SUPPLEMENTARY SITE INVESTIGATION INFORMATION

PROPOSED MIXED USE DEVELOPMENT LAND AT MILL STREET, LEOMINSTER

CC1189/SSII/REP07 Rev.A

MILL STREET, LEOMINSTER – EA OBJECTION – SV/2013/106961/01-L01

PETROL FILLING STATION
GENERAL ARRANGEMENT

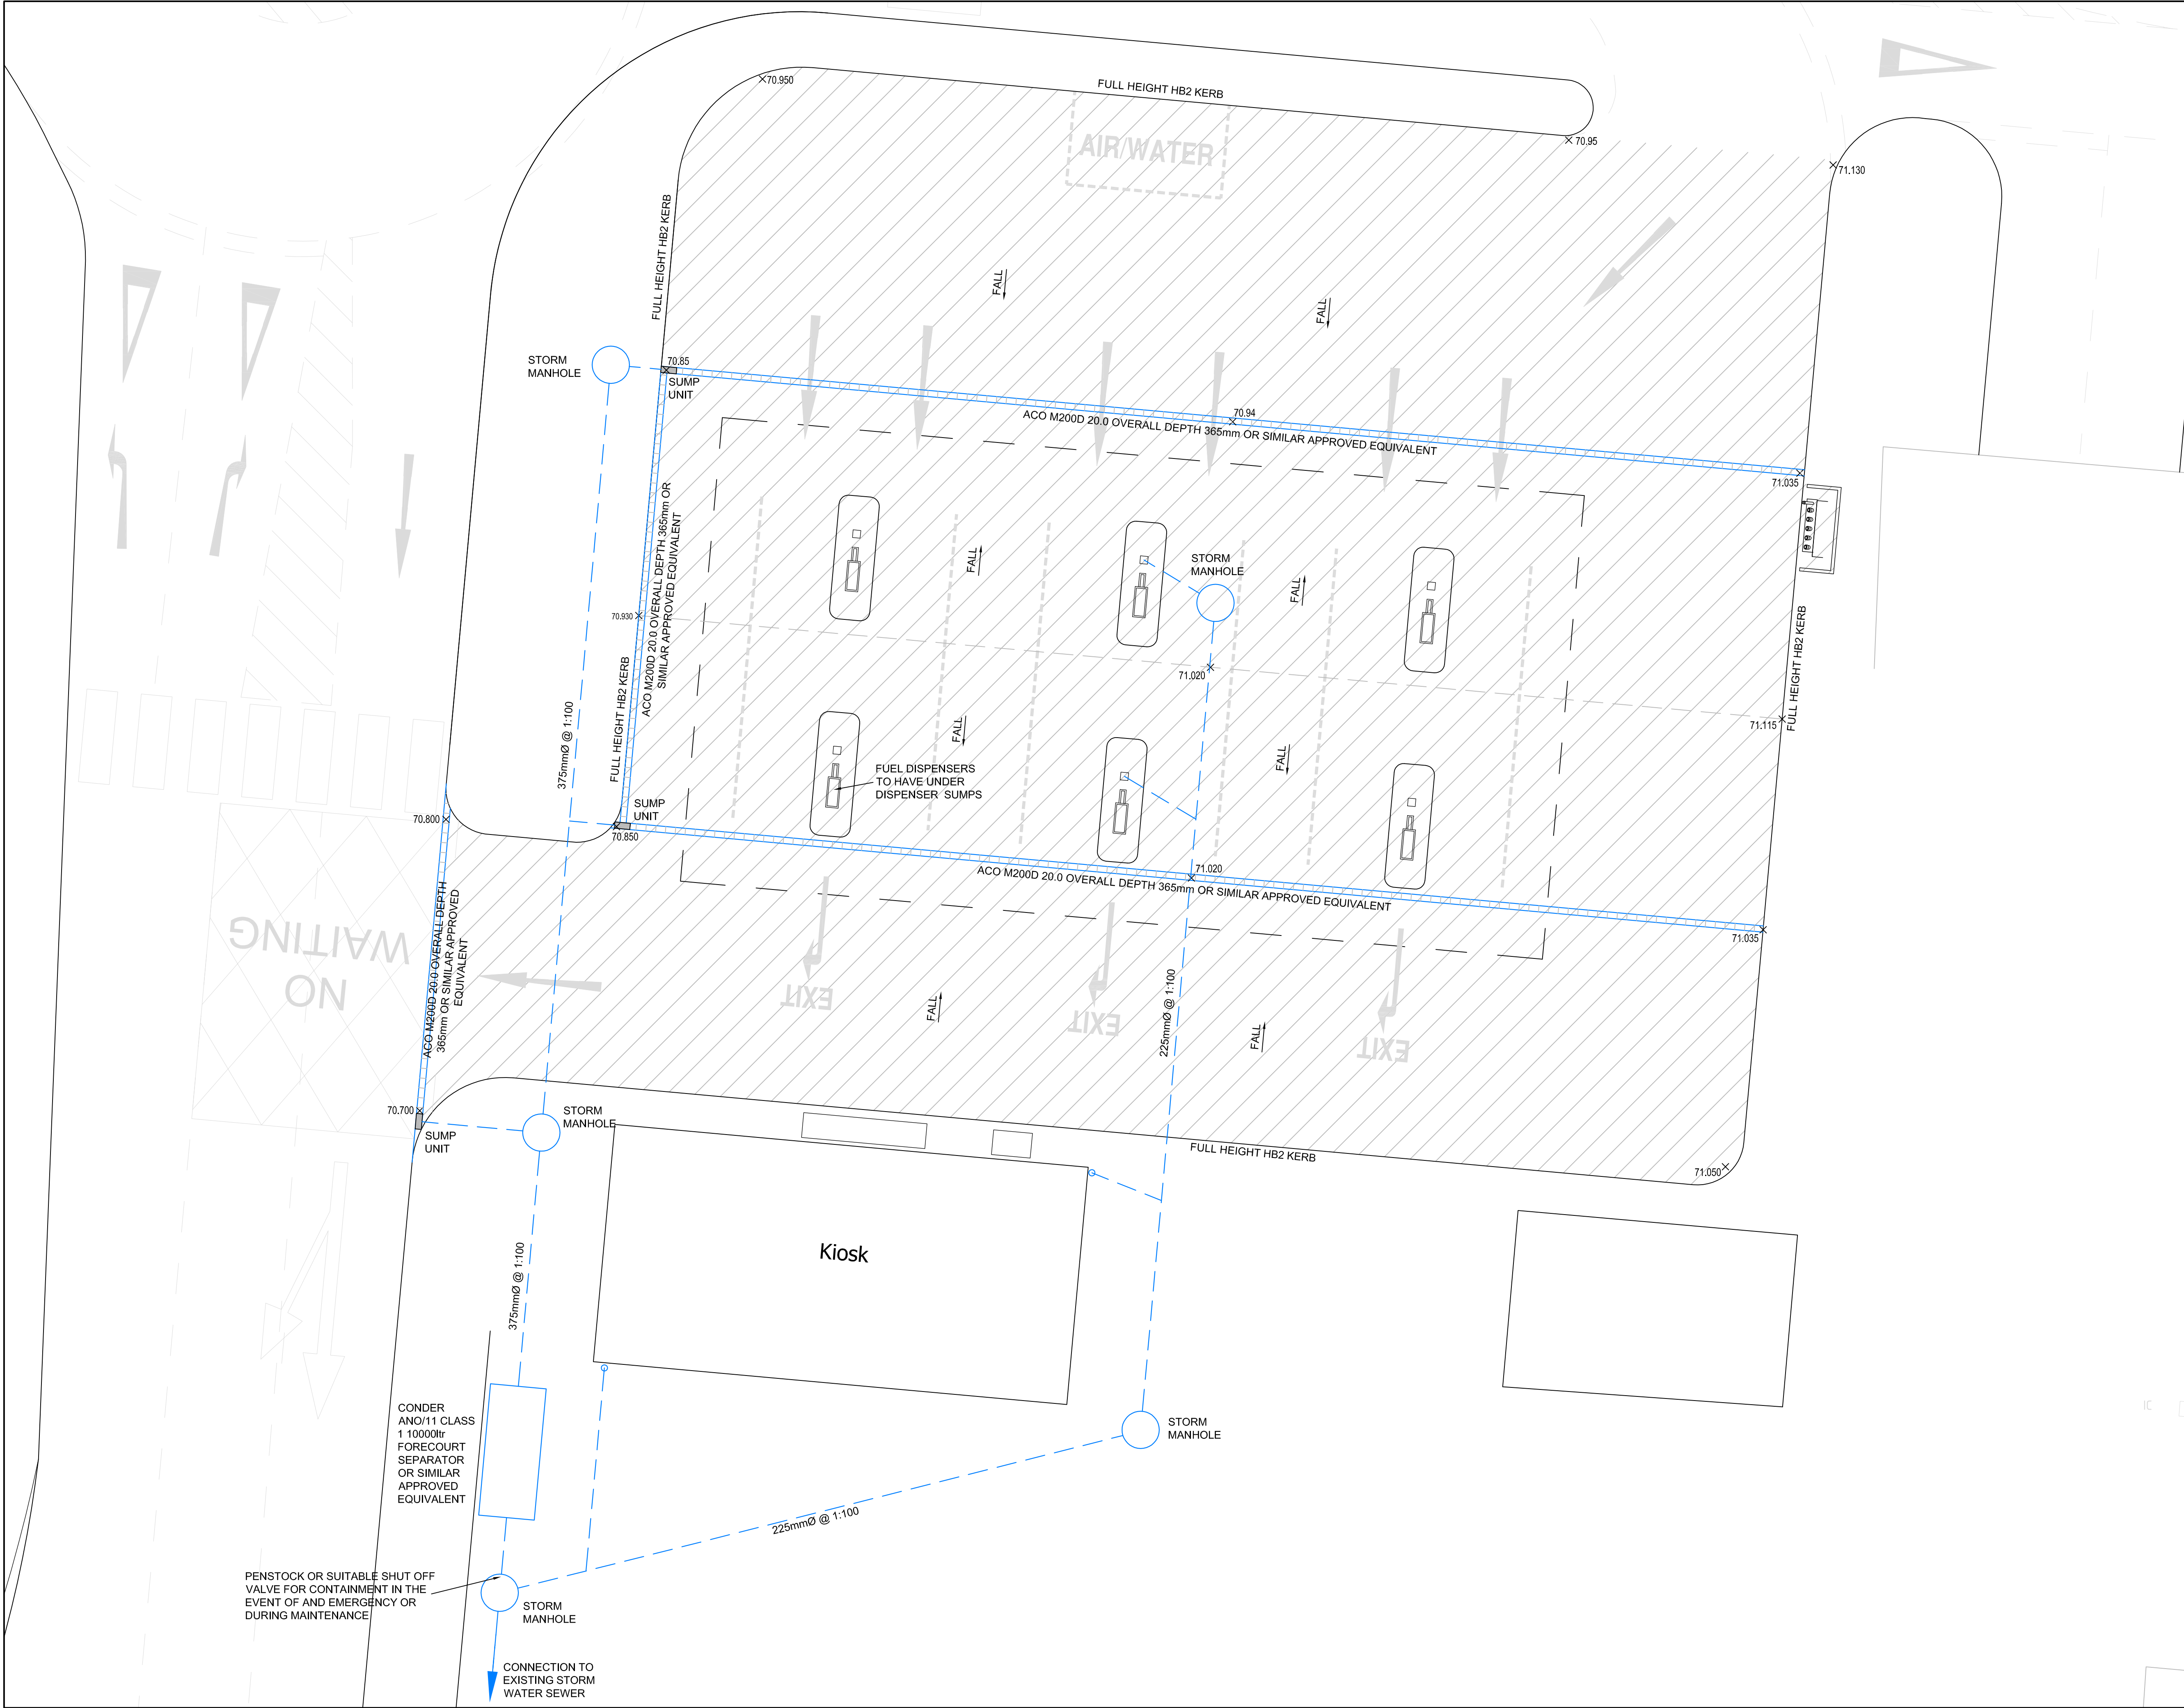
10	EA	<p>Petrol Filling Station: We note that a petrol filling station forms part of the proposals and we would offer the following comments in respect of this.</p> <p>We refer to Policy D3 'Sub-water table storage' (<i>Groundwater Protection: Policy and Practice (GP3)</i>, which is available at: http://www.environment-agency.gov.uk/research/library/publications/144346.aspx) which states: "We will object to storage of hazardous substances below the water table in principal or secondary aquifers". We would expect proposals for underground storage of pollutants in principal and secondary aquifers to be accompanied by a risk assessment appropriate to the volume and type of pollutants being stored and the hydrogeological situation. More detailed risk assessments and an infrastructure design method statement that meets BAT would be expected for storage within source protection zones or close to other vulnerable receptors.</p>

11	EA	<p>Related to the above we would raise a concern in relation to Policy D2 regarding underground storage (including fuel storage tanks). It states that objections will be raised to proposals on principal and secondary aquifers (outside of SPZ1) unless "there is evidence of overriding reasons" which indicate a) the activity cannot take place on unproductive strata (elsewhere); and b) the storage must be below ground.</p>

12	EA	<p>Adequate groundwater protection measures should be put in place to protect controlled waters from the possibility of any future underground fuel tanks (USTs) and associated fuel lines to dispensing pumps leaking. Historically, USTs do leak and contaminate the underlying aquifer, supply wells and boreholes and nearby watercourses. The PFS should be designed to highest of modern protection measures specification in order to protect the precious groundwater resource in the underlying aquifer(s) and the nearby watercourse.</p>
	Cambria	<p>Please find attached PFS Surface Water Drainage proposals and expected performance specification for the PFS equipment. The surface water drainage philosophy will satisfactorily collect all surface spillage over the impermeable area and successfully deliver it to a class 1 full retention petrol interceptor.</p> <p>We are still talking to specialist suppliers with regard to PFS equipment and leak detection capabilities. We would be very pleased to provide these details as soon as they are available.</p>

Cambria	<p>As discussed in our meeting, we are fully expecting and prepared to provide a full PFS Environmental Risk Assessment which will not only establish the desktop based protocols and HazOp considerations for spillage etc but will also consider the existing hydrogeological situation.</p> <p>Terra Firma Wales Ltd will undertake borehole investigations to collect aquifer soil for chemical and geotechnical analysis. The results of this testing will allow Terra Firma Wales Ltd to construct a hydro-geological model, using computer software, which can be used to model the predicted flow of groundwater and dissolved phase contaminants. We have also had recent experience of deriving site specific organic carbon partition coefficients (Koc) at the Cardiff University laboratories which provides a higher level of confidence for a site specific hydrological model.</p> <p>In addition, the boreholes would be used to determine hydraulic gradients which will be fed into the hydro-geological model. The boreholes would also allow long-term monitoring should this be necessary, and emergency monitoring should the storage system alarms trigger.</p> <p>We are very confident that we can provide a thorough risk assessment showing a very robust procedure for the prevention of leaks (double skins tanks, double skin fusion pipework, all PFS equipment installed with monitored leak detection). This will conclusively prove a negligible risk of pollution to the immediate groundwater and local River Lugg.</p> <p>Once the hydro-geological model has been determined to inform the risk assessment, we should be able to provide the complete assessment within two weeks. We would also hope at this time to have knowledge of the PFS equipment provider and specification. We would expect the manufacturer to be able to provide additional information regarding monitoring protocols etc.</p> <p>For the short term consideration, Terra Firma have produced a Preliminary Environmental Risk Assessment (see find attached).</p>

Site Layout

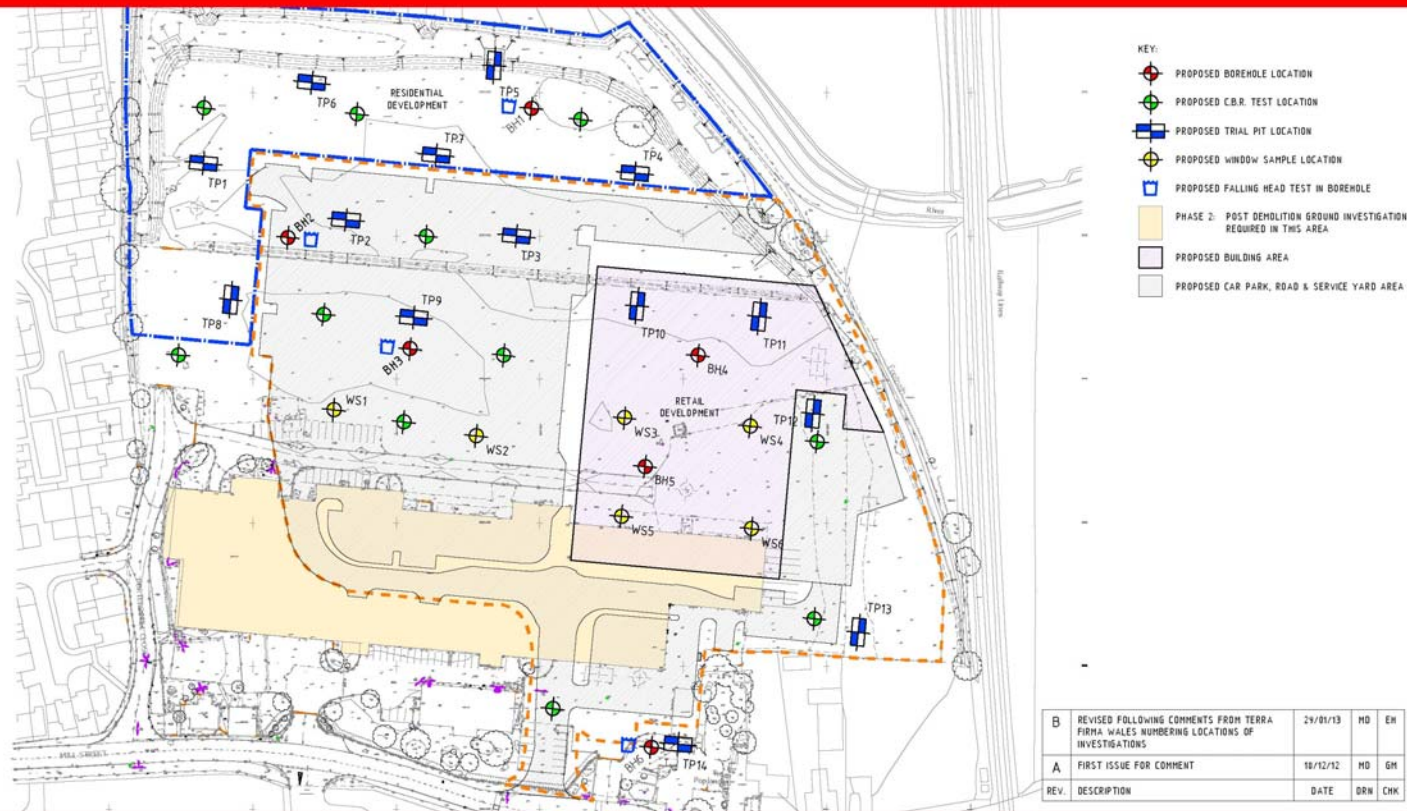
Cambria	We are utilising all documents and guidance as listed therein.
14	EA	The previous desk-study by Cambria Consulting found in Annex A supported the assessment of groundwater risks by the drilling of onsite boreholes and then sampling for water quality from those boreholes. A proposed site investigation plan is also provided in Part 2 of the report page 126. Is this plan where Terra Firma have drilled in the current investigation or is it the proposed Cambria Consulting plan from the desk-study report? The resolution of this plan is poor and it is hard to read in any detail. Does this location plan fit with the works already undertaken onsite? Are the borehole locations targeted to known contamination source/ process areas as discussed above? We would request an up to date location plan for the Terra Firma site investigation locations.
	Cambria	As suggested in previous responses the targeted approach is specific to the post demolition investigation. The initial investigation (which has been provided) was a matter of providing coverage (see attached Terra Firma plan)
